MCC/23/002/IU: Open service ports for Flow Family Anesthesia systems

Description of the issue

For users with system version 4.8 and above:

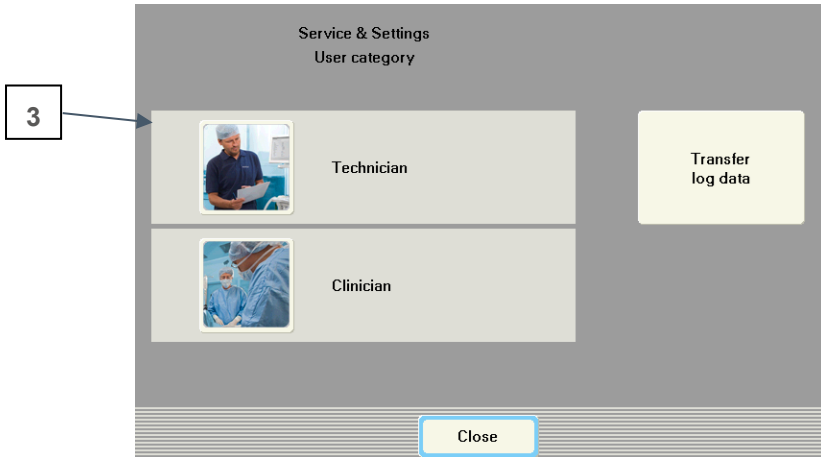
1. Select *Menu* on the screen
2. Select *Service & Settings*
3. Select *Technician* and enter the code 1973 for Biomed

4. Select *Connected Services* on the menu to the right
5. Select *Data transfer*
6. Select *Manual*
7. Select *Close*
8. After finishing step 7: *Remove the Ethernet cable from the Ethernet port on the Flow anesthesia system and the wall socket.*

For users with system version 4.7 and below:

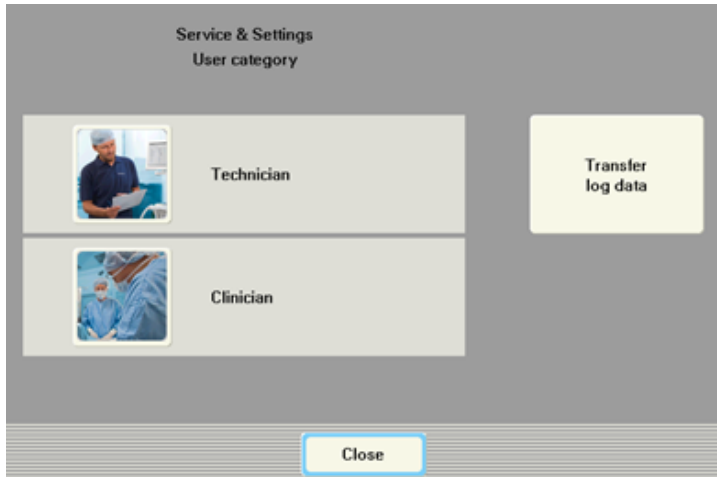
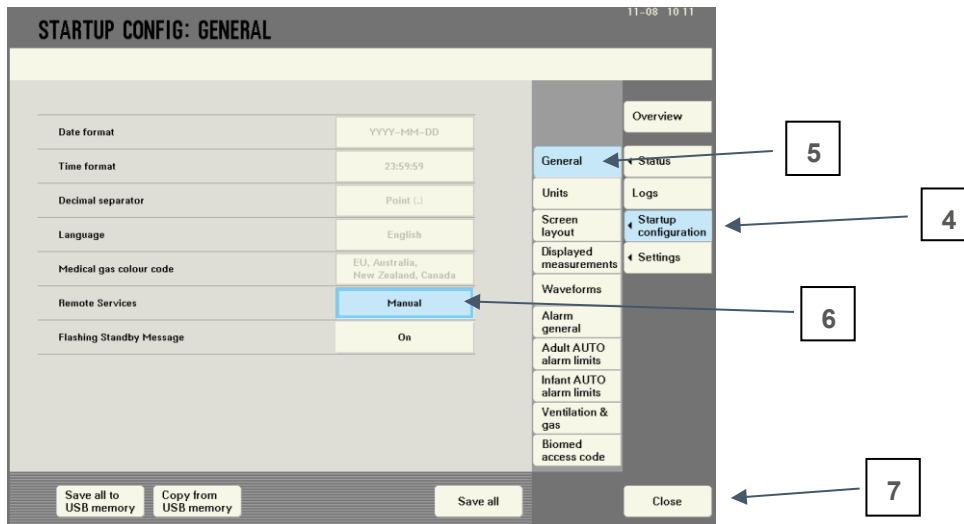
1. Select *Menu* on the screen
2. Select *Service & Settings*
3. Select *Technician* and enter the code 1973 for Biomed

4. Select *Startup Configuration* on the menu to the right
5. Select *General*
6. Under Remote Service select *Manual*
7. Select *Close*
8. After finishing step 7: *Remove the Ethernet cable from the Ethernet port on the Flow anesthesia system and the wall socket.*

Flow-c/e cover removal:

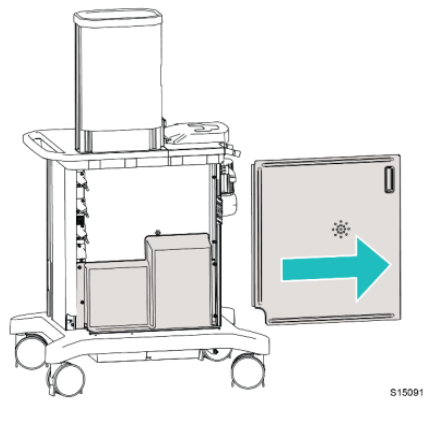
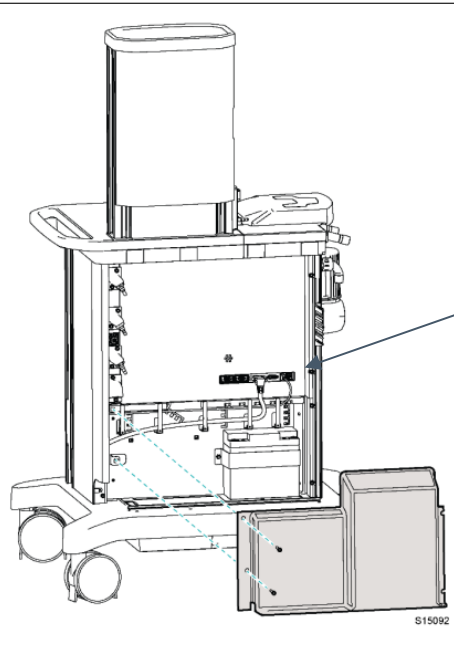
1. Pull the sliding door all the way to the right.

1. Loosen the two screws on the right side of the cover.
2. Unscrew the two screws on the left side of the cover.
3. Carefully lift off the cover over the guide rail on the carrier.
